ARKANSAS NUCLEAR ONE - UNIT NO. 1

AMENDMENT TO FACILITY OPERATING LICENSE

Amendment No. 47
License No. DPR-51

ARKANSAS NUCLEAR ONE - UNIT NO. 2

Figure 6.2-1 Management Organization Chart

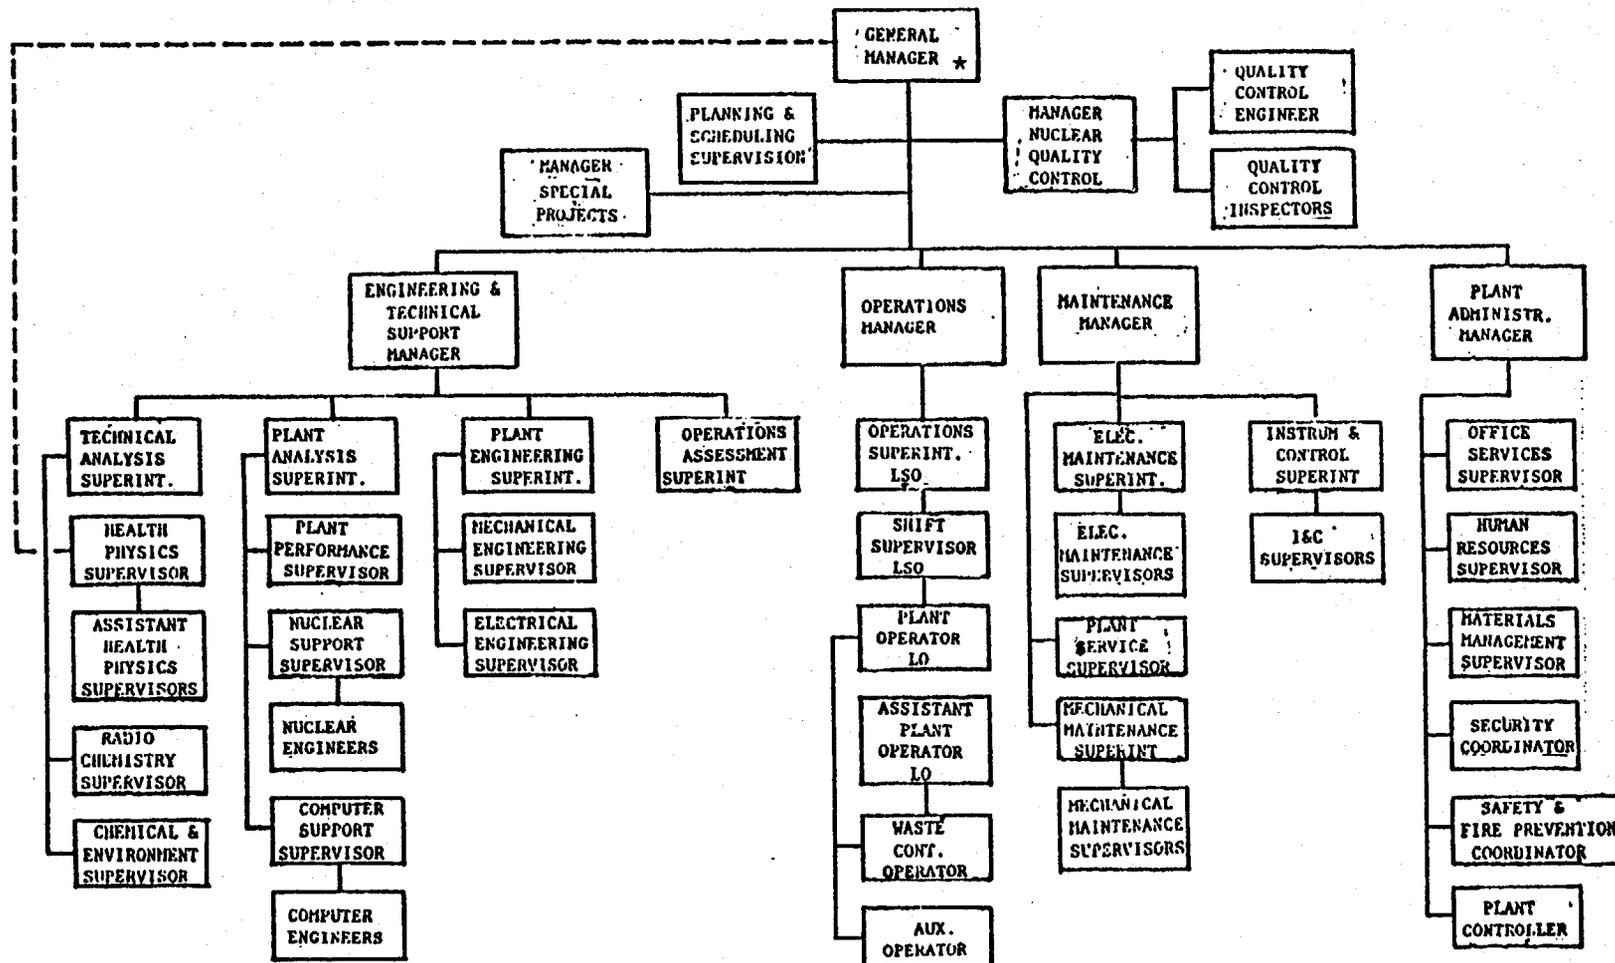
- 6.2.1 The offsite organization for facility management and technical support shall be as shown on Figure 6.2.-1.

We have reviewed and discussed with the AP&L staff the proposed changes to the ANO-1&2 Administrative Control Sections of the TS. We have made modifications to the proposed changes which have been agreed to by the AP&L staff. The position of Director, Generation Operations would be divided into Director, Fossil Operations and Director, Nuclear Operations to provide improved management resources to nuclear operations.

Figure 6.2-1 Management Organization Chart

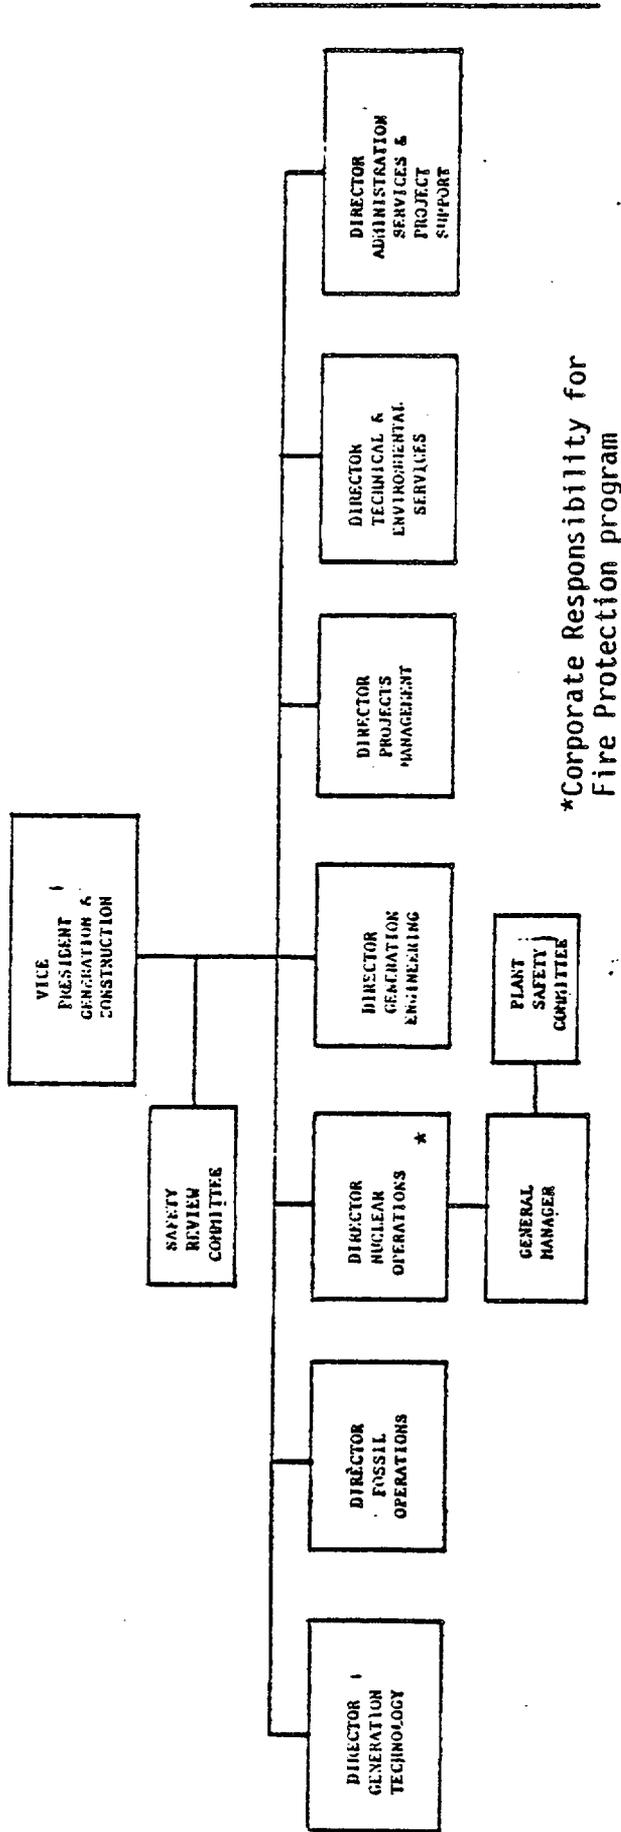
6.2.1 The offsite organization for facility management and technical support shall be as shown on Figure 6.2-1.

Figure 6.2-2 Functional Organization for Plant Operation

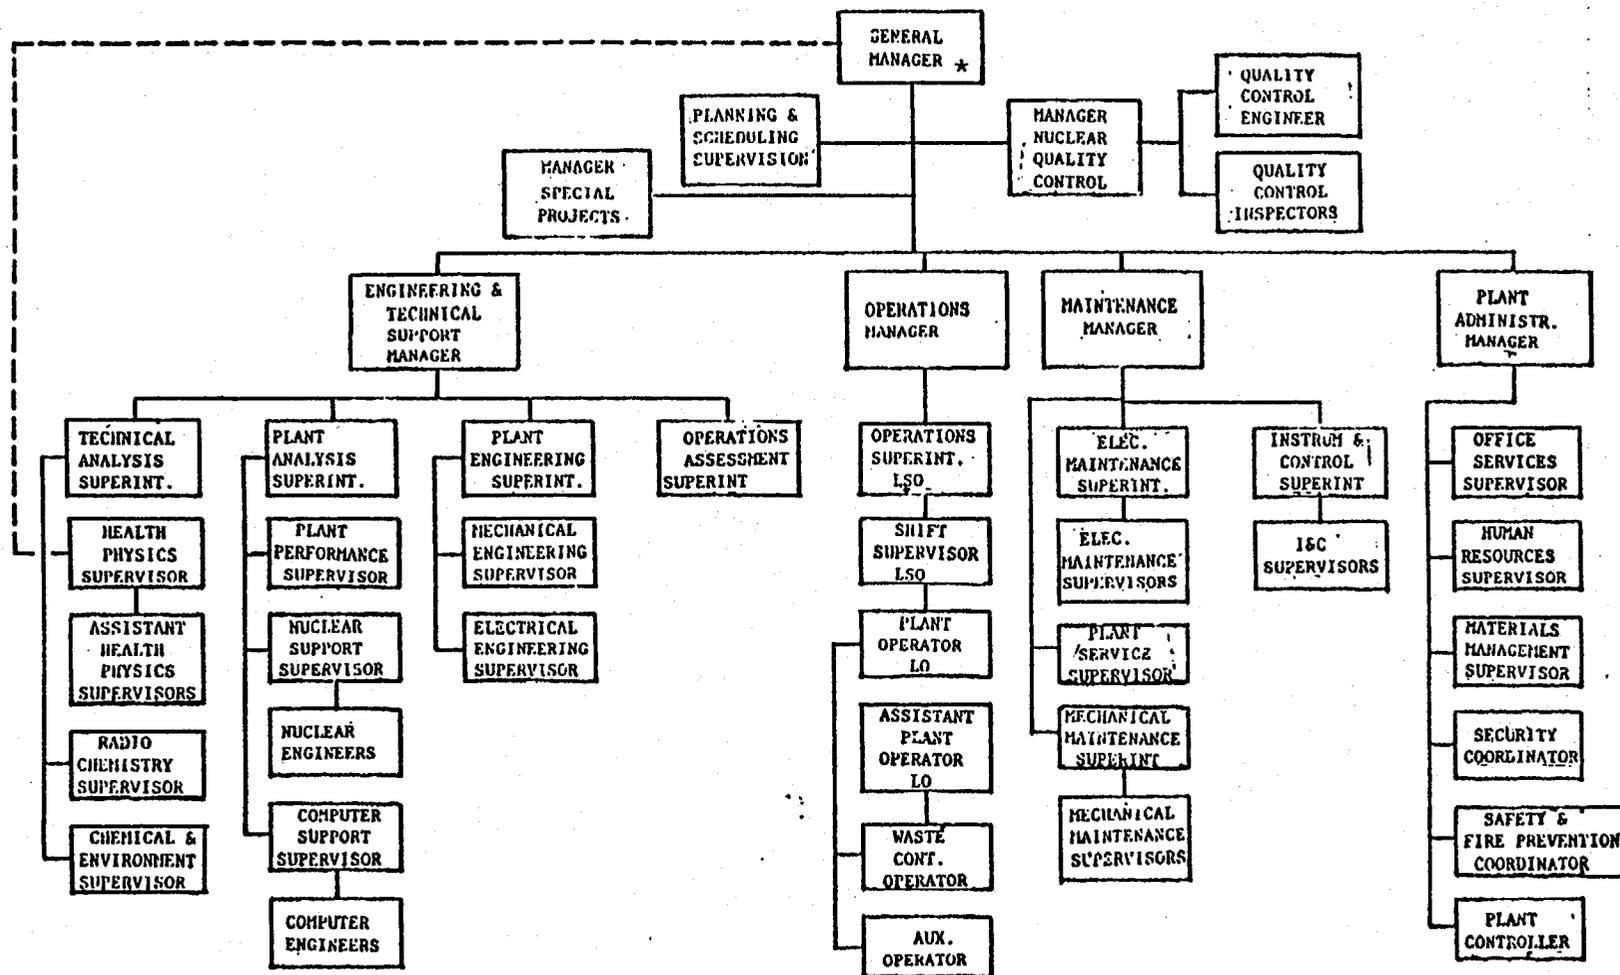
6.2.2 The Facility organization shall be as shown on Figure 6.2-2 and:
